**PLANNING DEPARTMENT
CURRENT PLANNING STAFF ANALYSIS
PLANNING AND ZONING COMMISSION**

DATE: April 8, 2024

CASE: S12738, Carol Creek Subdivision, Lots 1-115 and Tracts A-H, R1, R2, R3, and R4

REQUEST: Subdivision of one (1) tract into one hundred fifteen (115) lots and twelve (12) tracts, and variances from:

Preliminary Plat & Site Plan of
Carol Creek Subdivision
 Lots 1-115, Tracts A, B, C, D, E, F, G, H,
 R-1, R-2, R-3, & R-4

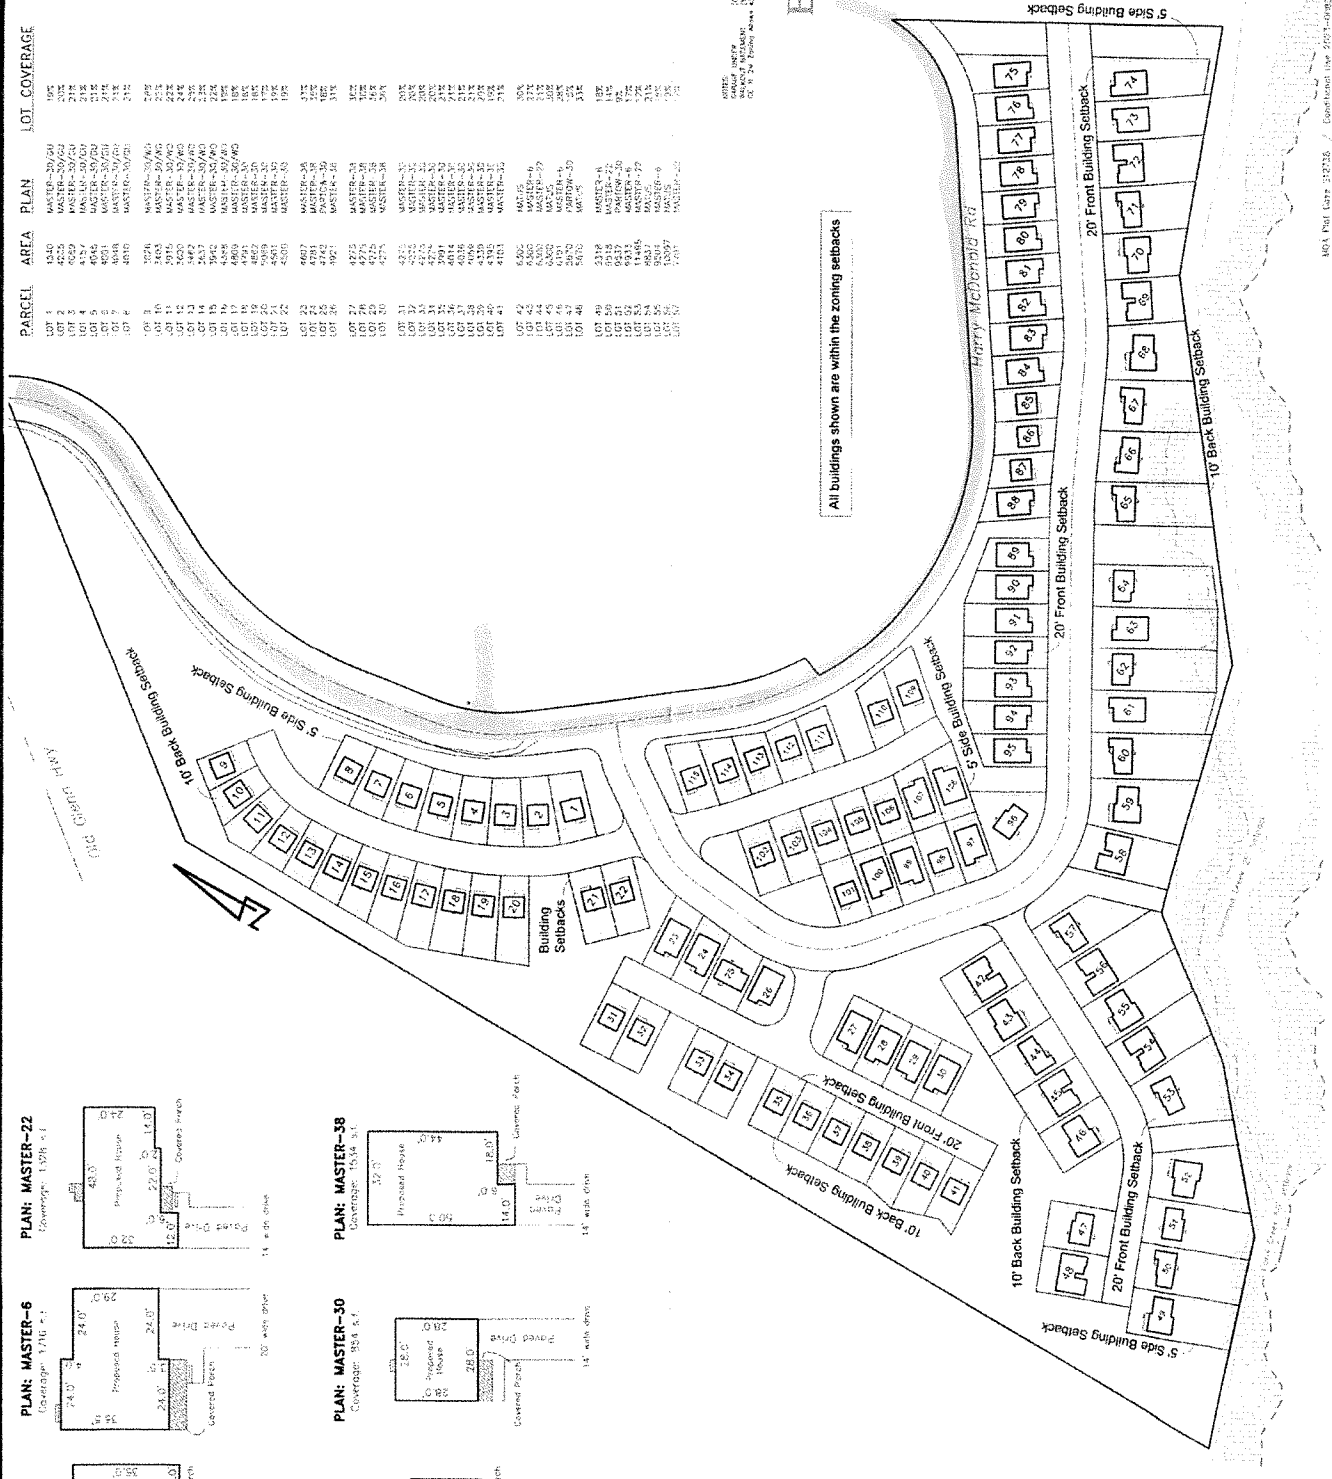
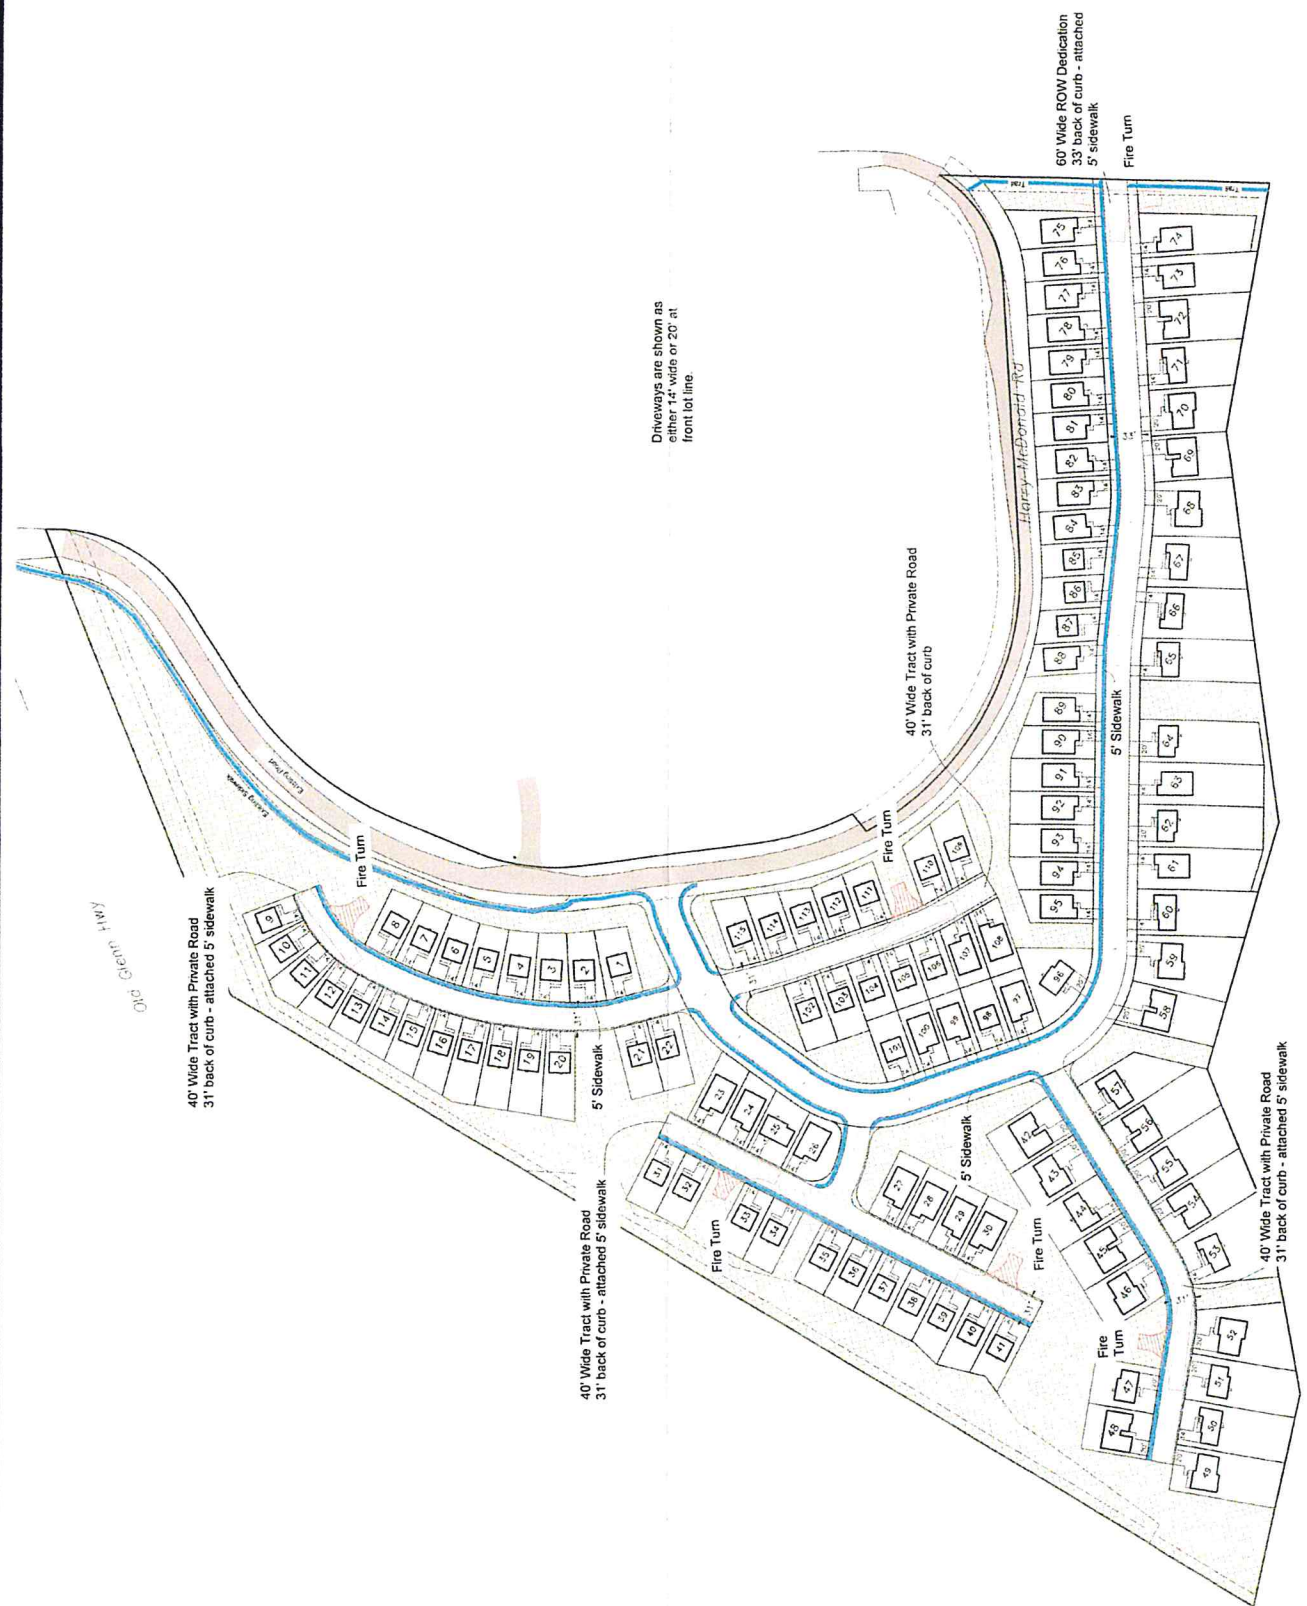
- a. The proposed plat note does not show a temporary turnaround at the end of the proposed 60' wide dedicate right-of-way.
- b. Place the following plat note:

The multiple dead-end private roads proposed within the subdivision will require accommodations for fire turnarounds. These accommodations are shown on the Roads & Sidewalks figure submitted with the platting application. However, the private road tracts do not accommodate the fire turnarounds. As a result, PM&E recommends adding the following condition to the plat:

- iii. The need to construct a paved temporary turnaround at the eastern terminus with Tract R3.
- 13) Submit to Private Development for review and approval a comprehensive site grading and drainage plan to resolve the need for drainage easements and drainage improvements and to demonstrate that all post development drainage patterns will not adversely impact adjacent properties or rights of way, and to include a suitable outfall. Required drainage improvements shall be designed in accordance with the Municipality of Anchorage Design Criteria Manual Chapter 2.
